CITY OF SACRAMENTO

- SUBJECT:
1. Negative Declaration
 2. Appeal of Planning Commission's Denial of various requests for property located at the southeast corner of Greenhaven Drive and South Land Park Drive
 - a. Amendment of General Plan from Agricultural to Residential
 - b. Amendment of South Pocket Community Plan from Interim Agriculture and Low Density Residential designations to Low Density Multiple Family
 - c. Rezone 18.6+ acres with portion of site in EA-3 from Single Family (R-1), and Agricultural (A), to Garden Apartment (R-2A) zone.
 - d. Lot Line Adjustment to merge three lots into one parcel totaling 18.6+ acres
 - e. Plan Review for 279 unit apartment complex (P85-047)

On May 28, 1985, the City Council heard the above entitlements for the proposed 279 unit apartment complex known as Fountain Oaks. The Council indicated an intent to approve the development subject to revised plans indicating two-family units along the south property line adjacent to the Park Place South halfplex development. The overall number of units would remain the same. Staff recommends approval of the revised site plan with conditions.

FOUNTAIN OAKS APARTMENTS
CONCEPT "B": DUPLEX UNITS
ALONG

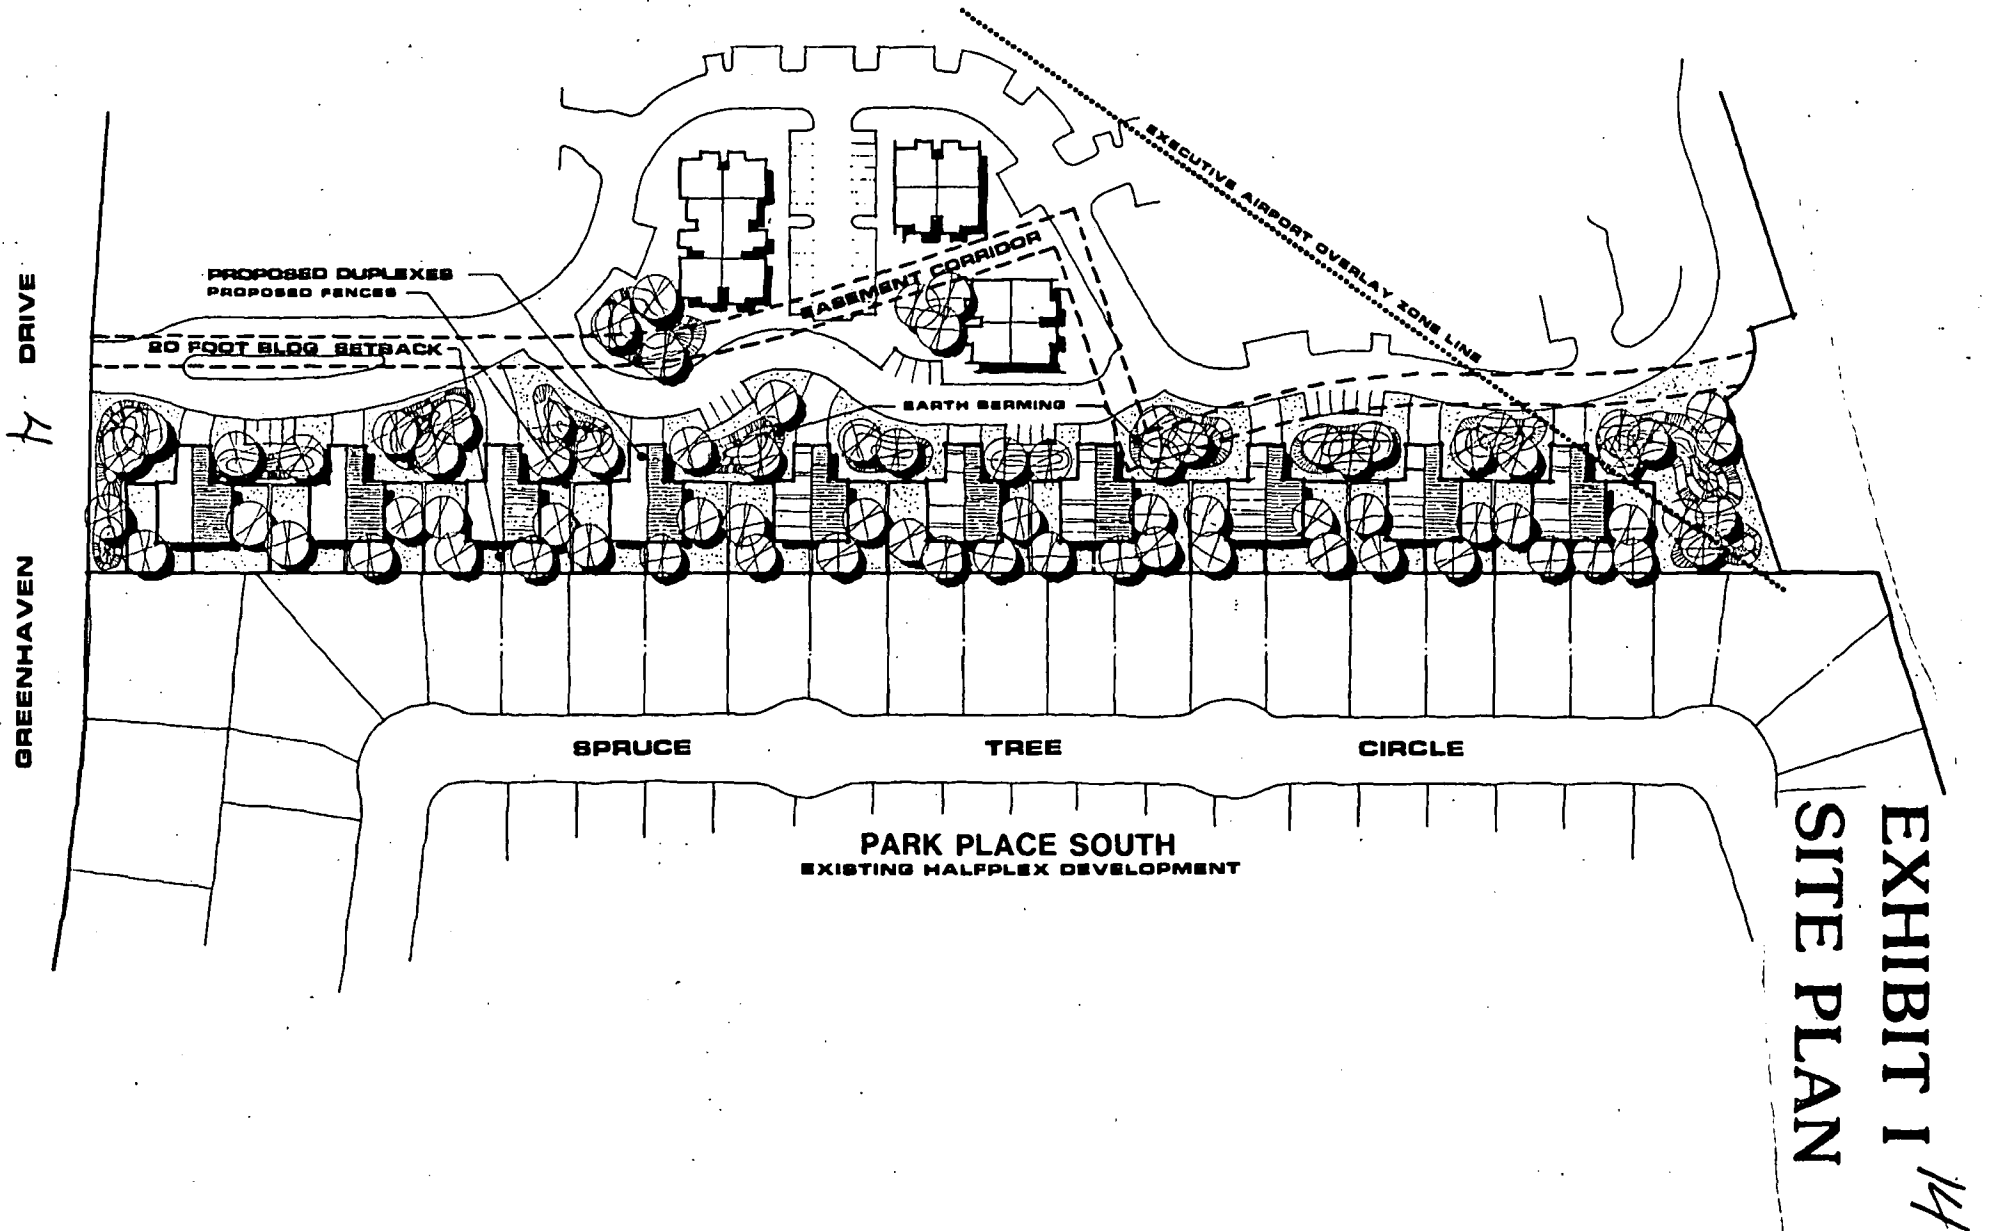
The Council directed the applicant to redesign the site plan to indicate two-family units along the south property line of the site. The two-family units were to:

1. have enclosed backyards with side fences;
2. be similar in design to the Park Place South units; and
3. include enclosed garages.

The applicant has submitted a site plan indicating 10 two-family structures (20 units total) along the southern property line (Exhibit I). Fence locations provide private yard areas with imaginary lot patterns similar to the adjacent Park Place South halfplex units. A 20-foot rear yard setback is provided between the units and the south property line.

1. Ratify the Negative Declaration;
2. Approve the Appeal subject to additional site plan review modifications and conditions and based upon Findings of Fact which are attached;
3. Adopt the attached Resolution amending the General Plan and Pocket Community Plan.
4. Adopt the attached Ordinance rezoning the site to the R-2A-R zone.
5. Adopt the attached Resolution approving the Lot Line Adjustment.
6. Approve the Plan Review for a 279 unit apartment complex.

EXHIBIT II ELEVATIONS FLOOR PLAN

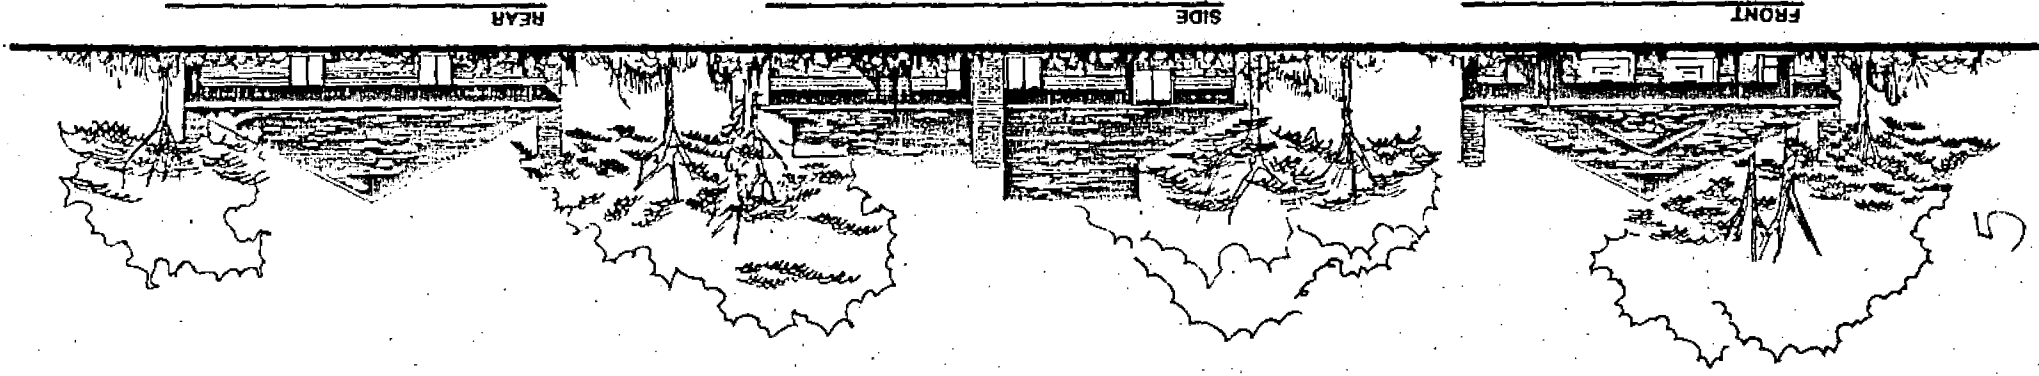
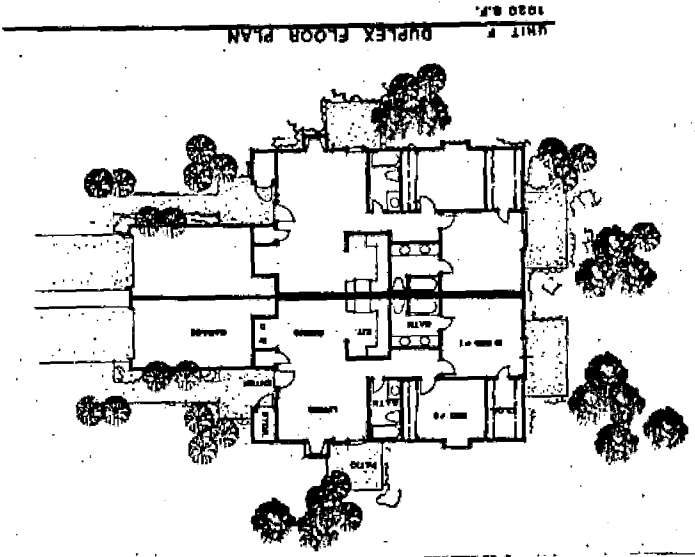
Proposed elevations indicate horizontal wood siding with wood shake roofs (Exhibit II). These building materials are similar to the Park Place South units and compatible in design to the proposed apartment units. If further variation is desired, a brick trim could be incorporated into some of the units and different colors used.

Floor plans indicate a one-car enclosed garage and 1,020 square feet of living area including two bedrooms, two baths, living room, dining room and kitchen (Exhibit II). Park Place South units have two-car garages and range in size from 1,293 to 1,700 square feet (Exhibits III-a and III-b). The number of rooms on many of the plans remain the same except that an entry hallway is included at Park Place South. It should be noted that another difference between the two developments is that Park Place South allows for individual ownership of each unit while the proposed two-family would remain rental units and part of the Fountain Oaks Apartment development. To require all of the proposed units to include two-car garages with square footage ranging from 1,293 to 1,700 may create an undue hardship for a rental situation. Staff therefore recommends that four of the proposed structures, (8 out of 20 units), including the structure adjacent to Greenhaven Drive, be expanded to include a two-car garage and a minimum of 1,200 square feet of living area.

The proposed two-family units have been reviewed by the Park Place South Homeowner's Association. They have indicated the following concerns:

1. the size of the proposed units are not comparable to the square footage of the Park Place South units and should be enlarged;
2. the two-family units should be built to halfplex standards; and
3. the apartment units should be built to the City's Condominium standards.

The applicant has no objection to constructing the two-family units to halfplex standards, however does object to building the apartment units to condominium standards. The Council did not direct staff, however, to include these building standards as a condition of approval.

Exhibit 4

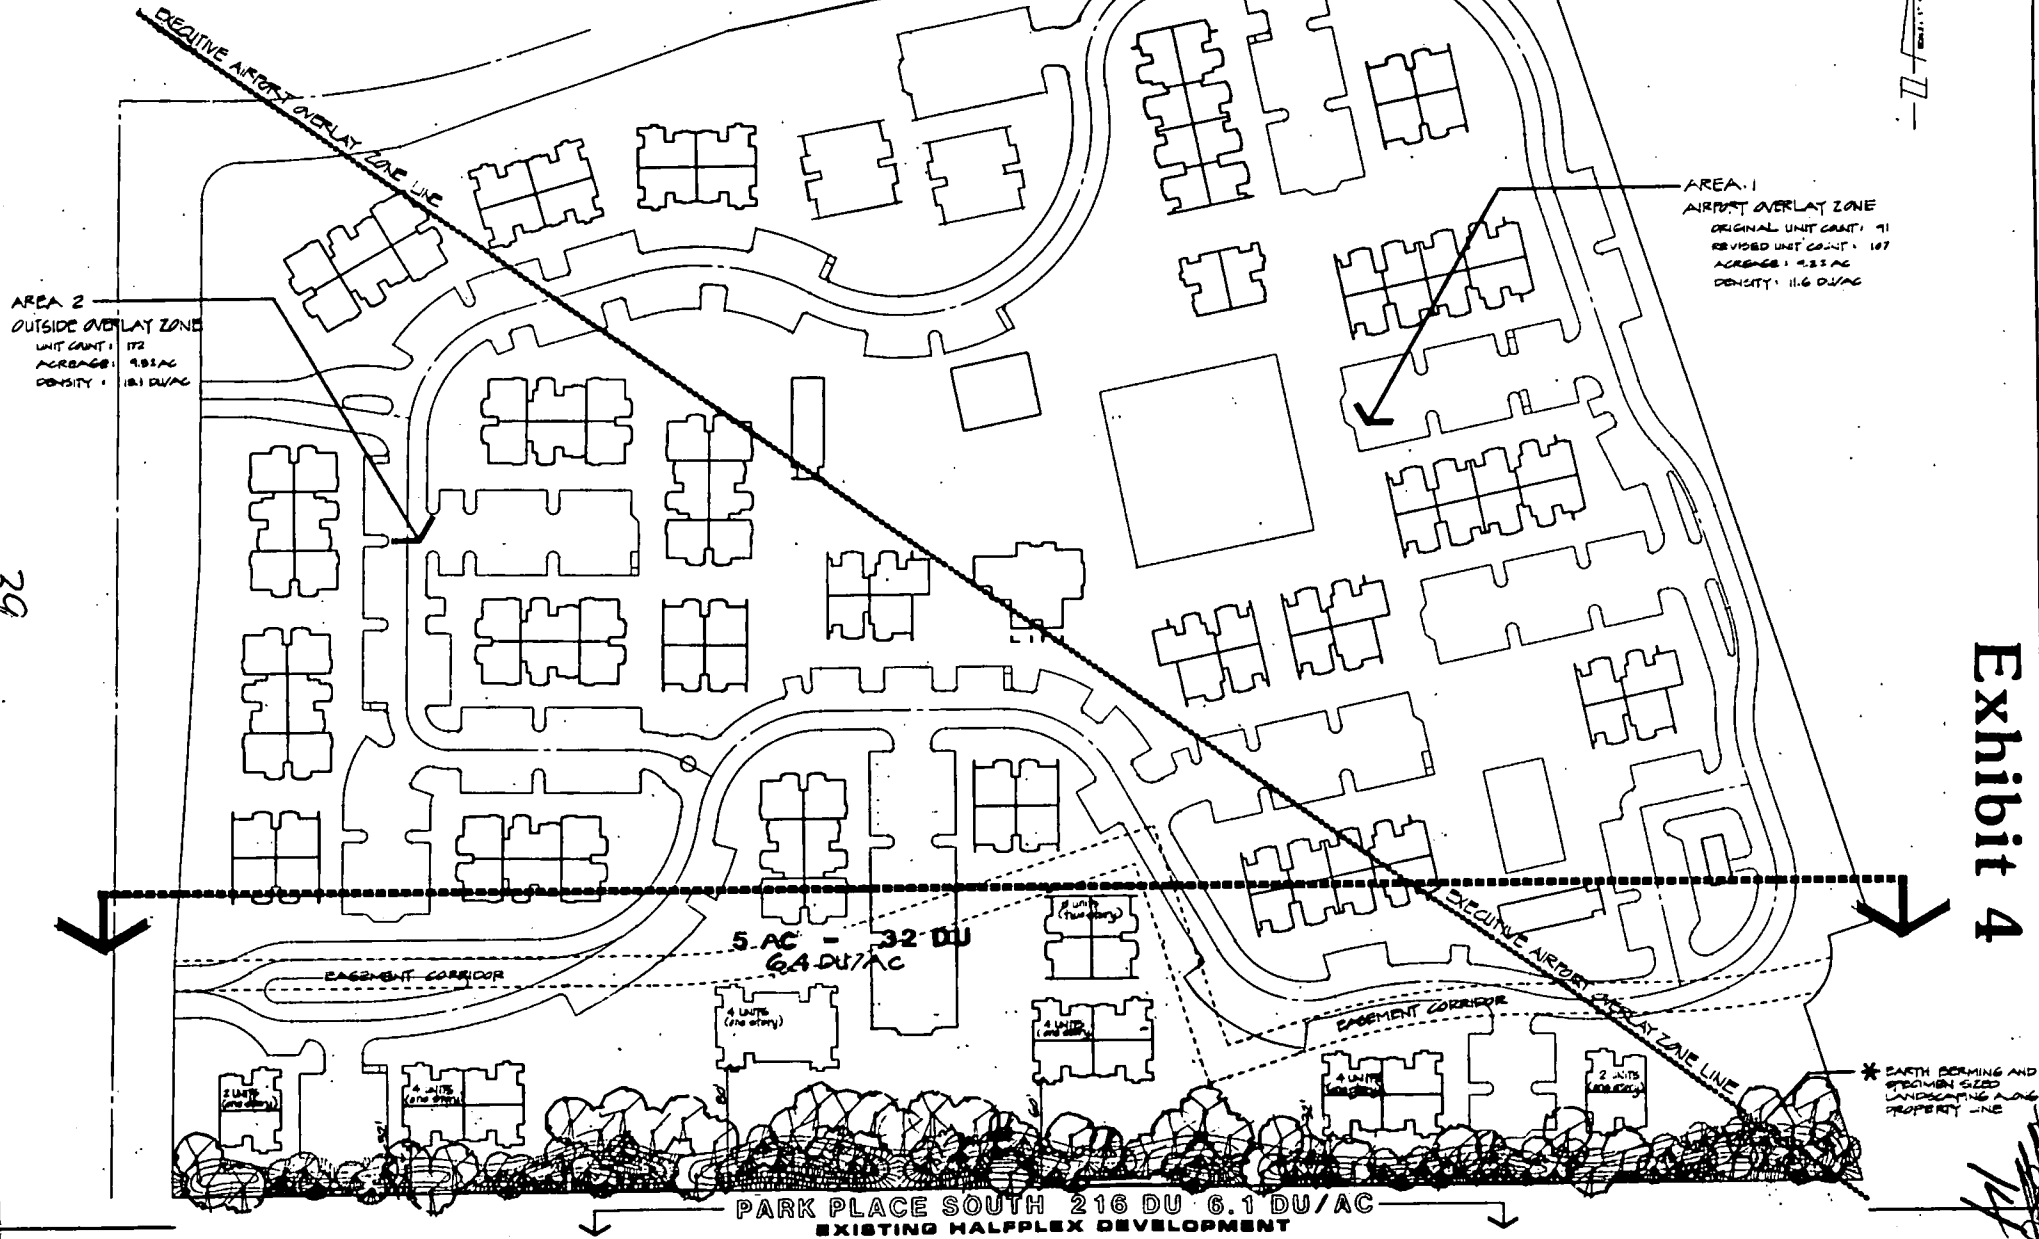
Subsequent to the Planning Commission's decision the applicant has met with the Park Place Homeowner's Association to discuss two alternative site plans. Attached is an alternative plan transmitted from the applicant (Exhibit 4). The plan has not been reviewed by the Planning Commission. Staff does not know at this time whether or not a consensus has been reached between the applicant and the Homeowner's Association.

1) The site plan shall be consistent with Exhibit 4, page 17 of the staff report; provided, however, the buildings adjacent to Greenhaven Drive and South Land Park Drive shall be rotated with varied setbacks.
